Engineering Change Notification

NHD-4.3-480272EF-ASXV#
NHD-4.3-480272EF-ASXV#-CTP
NHD-4.3-480272EF-ASXV#-T

NEW TFT

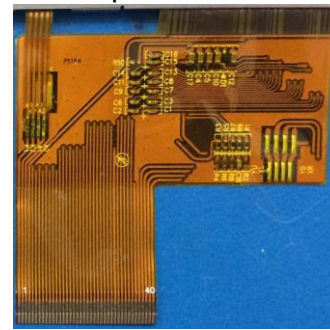
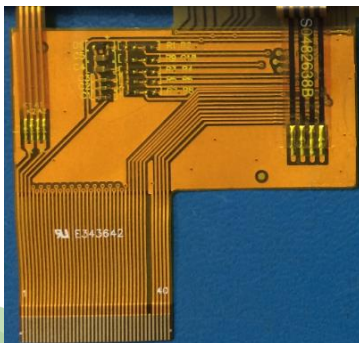
The built-in TFT driver has been changed from Himax HX8257-A to [Sitronix ST7282T2](#).
The TFT FPC has also been redesigned to match the new driver's requirements.
